Vermont Yankee Nuclear Power Station

Proposed Technical Specification Change No. 263 – Supplement No. 10

Extended Power Uprate

Response to Request for Additional Information

FIGURE 1 - Modification for Recycling Cooling Wtr to RHRSW Pump Motor Bearing Oil Coolers

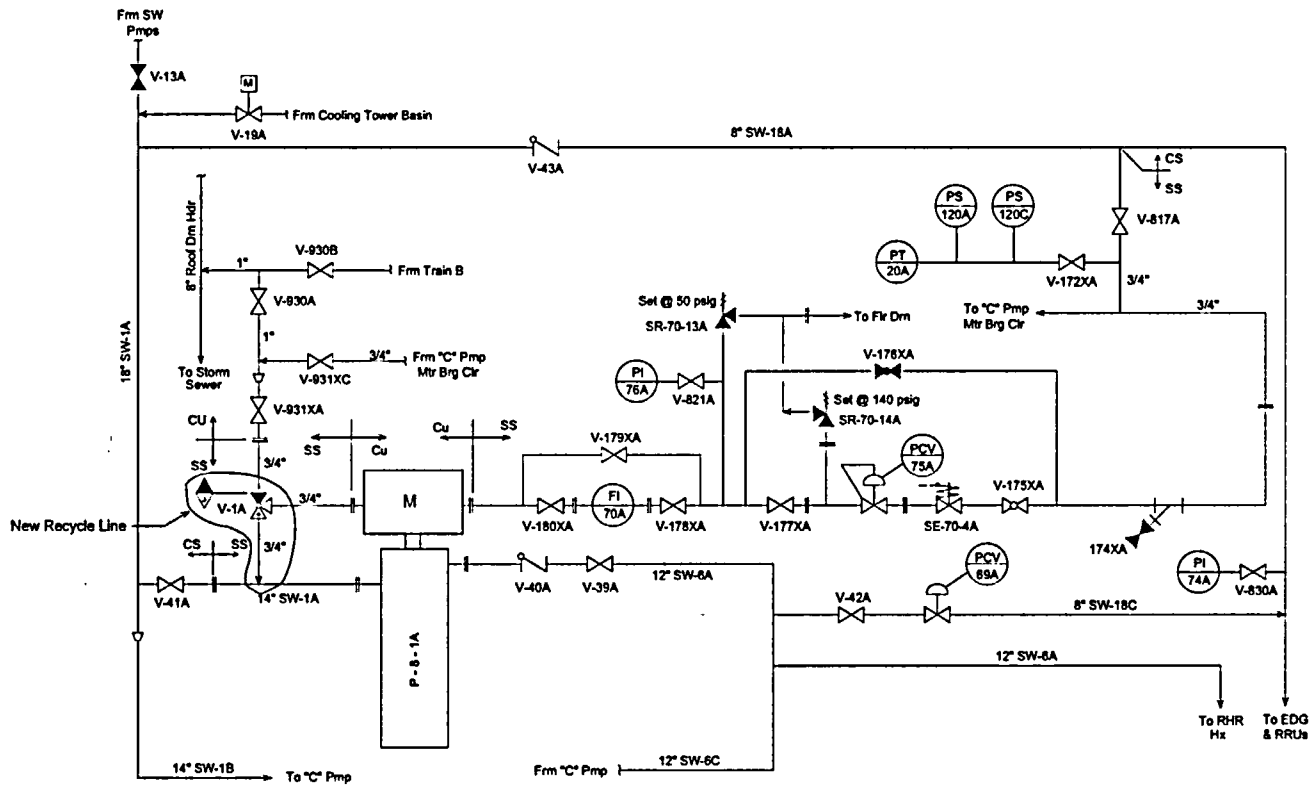
d) In Reference 1, Attachment 6, Section 6.4.5, as well as in Reference 5, Attachment 6, MATRIX 5, Page 8, SE 2.5.3.4, it is stated that a modification to re-circulate ACS (RHRSW) pump motor cooler water back to the cooling tower, instead of discharging it to the river, is planned to ensure adequate inventory to meet the 7-day requirement associated with the ACS design-basis functional scenario. Please provide a description of the modification, including a flow diagram. In addition, discuss the regulatory requirements applicable to the modification.

- c) The service water supply temperature is in accordance with the plant design basis of 85°F as discussed in UFSAR section 10.6.5. For ACS operation, see the above response to part (a).
- d) For purposes of the following discussion, refer to the SW system flow diagram included below as Figure SPLB-A-9-1. For each pump in each train of the RHRSW system, this minor modification involves the addition of a new 3-way ball valve in the motor bearing oil cooling water (MBOCW) return piping that will allow routing of the cooling water back to the pump suction line during ACS mode operation only to save cooling tower basin water inventory. This new line will connect to the existing 14-inch diameter pump suction piping. The second outlet port of the three-way ball valve will be connected to the existing piping that connects to the reactor building storm drains.

This change will have negligible impact on system hydraulics or the PRA model. The new ball valve is a full-ported type that offers minimal resistance to fluid flow. For normal plant operation and post-LOCA recovery, the system will be configured and operated in a manner that is identical to that called for by the current design, except that the cooling water will be routed through the three-way ball valve. Since the system will normally be set in this alignment, no additional valve manipulation is required and the increase in human error probability (HEP) for normal or post-LOCA operation is consequently very small. For ACS operation, the only new operator action required is to reposition the 3-way ball valve. Therefore, for ACS operation the increase in HEP is very small.

From a hydraulic performance point of view, aligning the MBOCW discharge to the pump suction rather than to the storm sewers actually represents a considerable improvement since the hydraulic resistance is significantly reduced (due to the shorter length of piping and lower discharge point back pressure).

The pipe routing for each new MBOCW return line will have no impact on other safety related SSCs since the RHRSW pump which it services is the only SSC in the vicinity of the new line.
